GOVERNMENT/INDUSTRY AERONAUTICAL CHARTING FORUM
Instrument Procedures Group
April 18, 2006
HISTORY RECORD

FAA Control # 06-01-263

Subject: Uniform Application of FAA Order 7130.3A RNAV Charted Holding Pattern Lengths

4. AIR TRAFFIC REQUESTS APPROVAL OF REFERENCED FIX FOR:										NAME: PRESN, ID		
A. REPORTING POINT		COMPULSORY		AIRSPACE STRUCTURE FOR WHICH FIX IS DESIRED				X LOW ALTITUDE				
		ON REQUEST						HIGH ALTITUDE

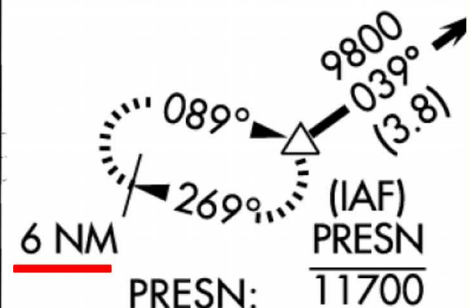
Attached is Table 8, which shows the leg length selection table, predicated upon the Pattern Number used for obstacle clearance. At both Cortez, CO (KCEZ) and Sun Valley, ID (KSUN), Pattern Size 10 was correctly used for obstacle clearance evaluation because, in both locations, the minimum holding altitude is 9,800 feet. Also attached are excerpts from the applicable Form 8260-2 that documents Pattern 10 for the holding fixes at both locations. Note that PRESN (KSUN) has a charted leg length of 6 NM, but YURVE (KCEZ) has a charted leg length of 8 NM. According to 7130.3A, Table 8, the leg length for both locations should be 7 NM. In the KSUN case the pattern length is unnecessarily restricted, but in the KCEZ case, the pattern is longer than permitted, which could erode lateral obstacle clearance. The National Flight procedures Group (NFPG) has informed NBAA the variances are the result of lack of policy guidance.

Recommendations: AFS-420 should provide precise guidance to AVN-100 that Table 8 of Order 7120.3A is to be applied to the pattern size used to determine the controlling obstruction, not the pattern used for airspace purposes. The safety issue in this matter is uniform protection from possible laterally higher obstacles. The obstacle risk is unknown because procedures are not evaluated for obstacles outside containment areas.
